Operational Transport Management Plan

Cudgen Lakes Sand Quarry

Project Approval No. 05_0103 (MOD2)

May 2020

Figure 1
TRAFFIC MANAGEMENT AND PARKING

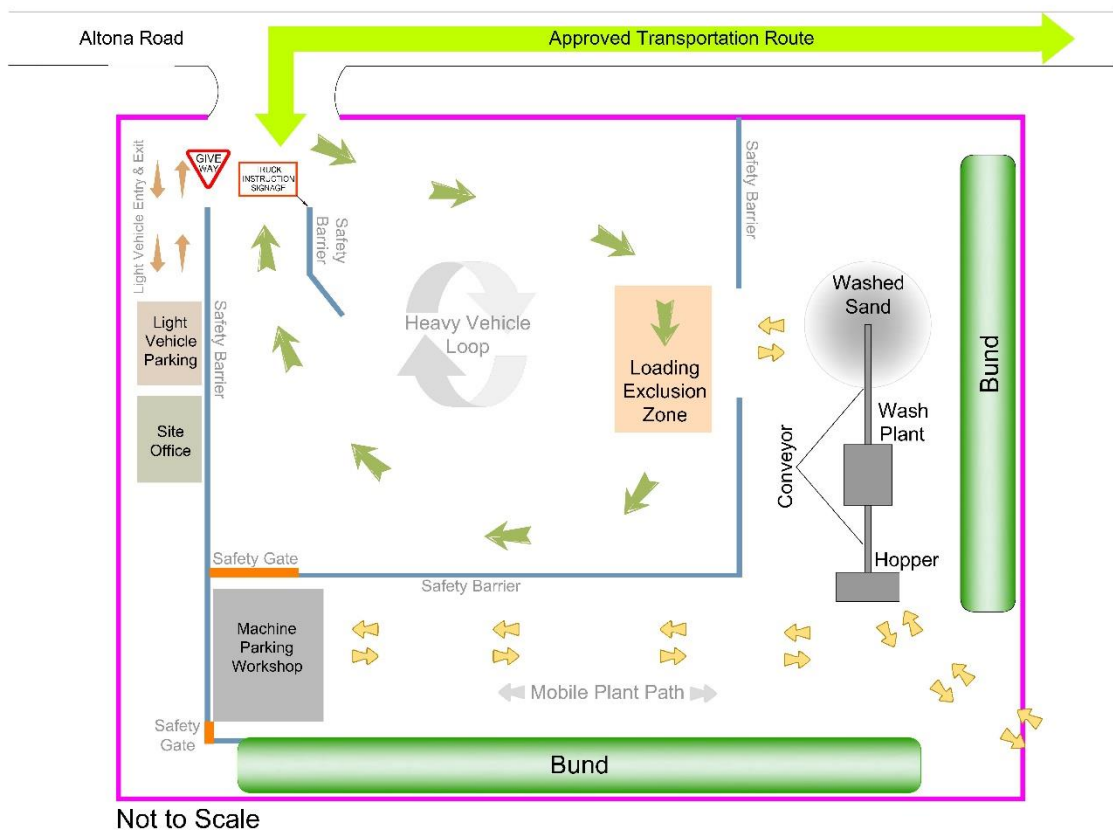
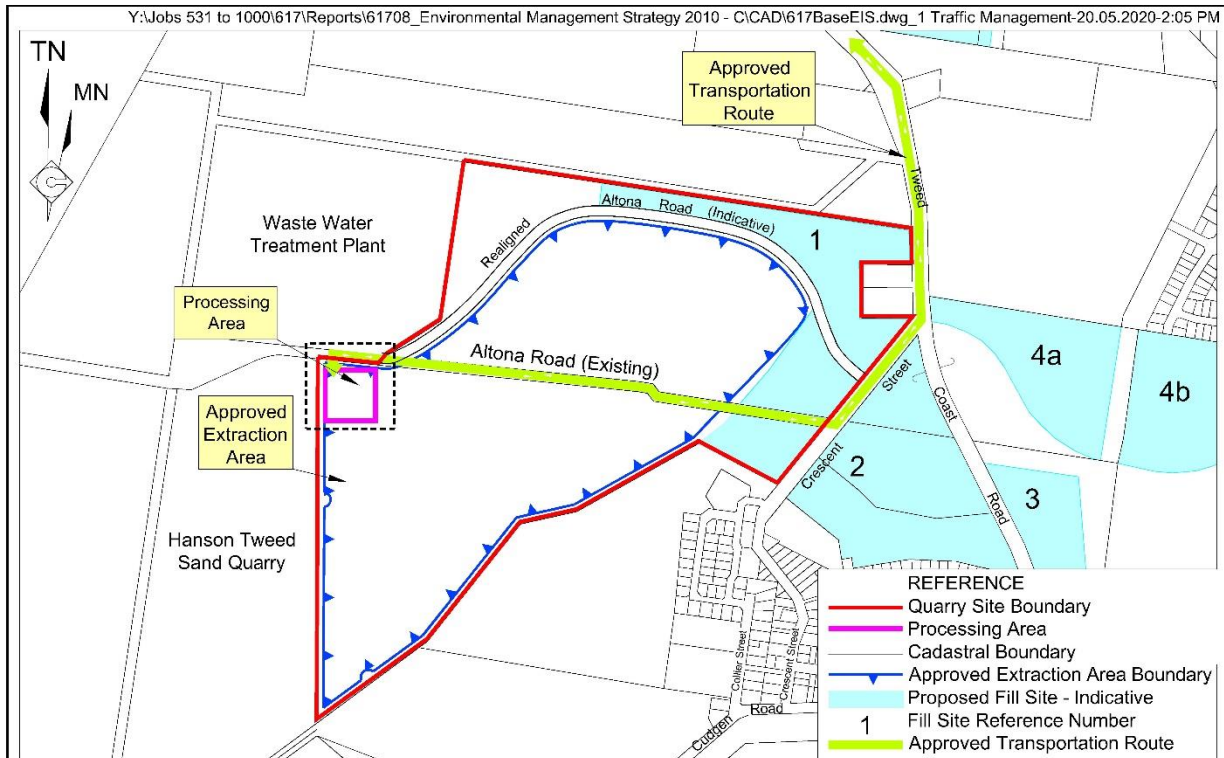
- Exiting truck movements need to be regulated internally by defining their path with physical barriers and signposting to reduce conflicts with entering light vehicles.

Agency	Comment	Coverage
Transport for NSW	Exiting truck movements need to be regulated internally by defining their path with physical barriers and signposting to reduce conflicts with entering light vehicles.	Figure 1 updated to include additional safety barriers which create a defined exit path for trucks. Additional instructional truck signage also included at this defined exit path.
Tweed Shire Council	There are some incorrect references regarding Conditions 3(27) and 3(29) of the MOD 2 consent in section 3 of your document.	Section 3 reviewed and cross references updated as applicable.
	Matters relating to Altona Road upgrades refer to condition 3(27). Matters relating to the Tweed Coast Road – Crescent St intersection relate to 3(29) and this needs to get added to your summary table of applicable traffic conditions.	Condition 3(29) added to Table 1 (Project Approval Requirements Relating to Transportation).
